**CTV-SB-76**

**SUBJECT: NUISANCE "DISTRIBUTION FAULT" TRIPS FOLLOWING UNIT SHUTDOWN**

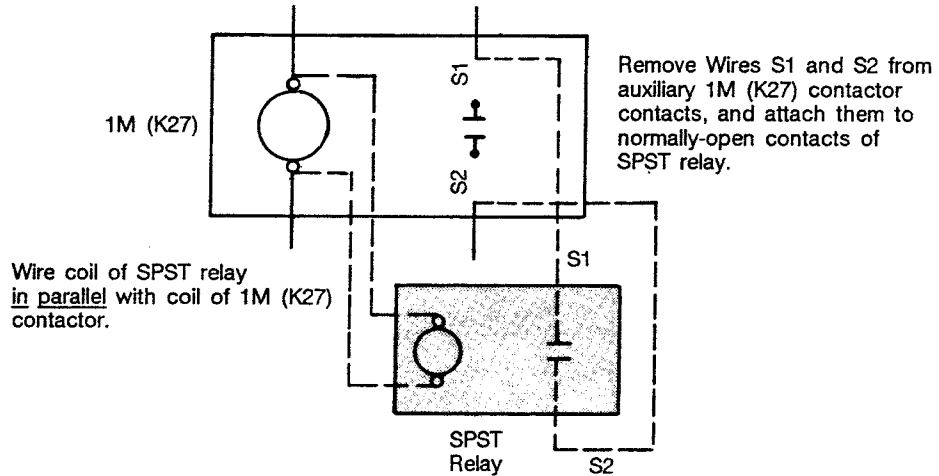
When a unit is protected by the Cutler-Hammer SSOL motor/starter protection system, existence of a distribution fault condition is detected within 1-1/2 electrical cycles; within 6 electrical cycles, the motor is off-line. SSOL recognition of a distribution fault is based on the status of the S1-S2 circuit (auxiliary on 1M) and motor amp draw: If the S1-S2 circuit remains closed while line current is less than 15% of RLA, a distribution fault exists.

In star-delta starter applications, this situation can occur if the 2M (K28) contactor opens, interrupting current to the motor, while a sluggish 1M (K27) contactor--or unresponsive auxiliary 1M contacts in the S1-S2 circuit--remains closed. As a result, the SSOL interprets what should be a normal, scheduled shutdown (i.e., one initiated with the unit ON/OFF switch) as a distribution fault, and trips the distribution fault indicator.

**Example A**

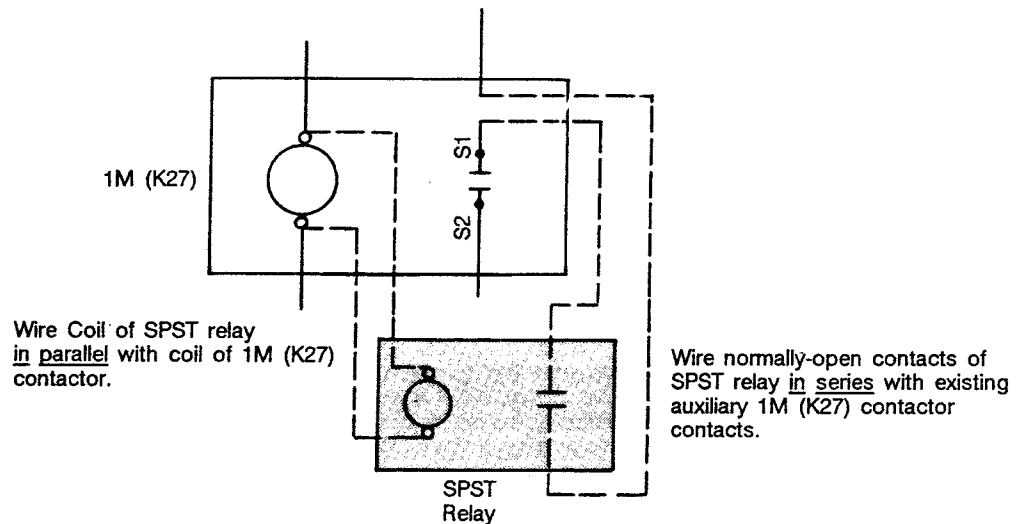
In the event that the 1M (K27) contactor is found to be in good condition—and neither adjustment nor replacement of the auxiliary contactor contacts eliminates the nuisance trip problem, wire a single-pole, single-throw relay into the distribution fault circuit. The addition of this relay ensures that the S1-S2 circuit opens as soon as the coil of the 1M (K27) contactor is de-energized (even though the auxiliary 1M contacts may still respond slowly).

Examples A and B illustrate two alternative methods for adding the SPST relay to the distribution fault circuit.
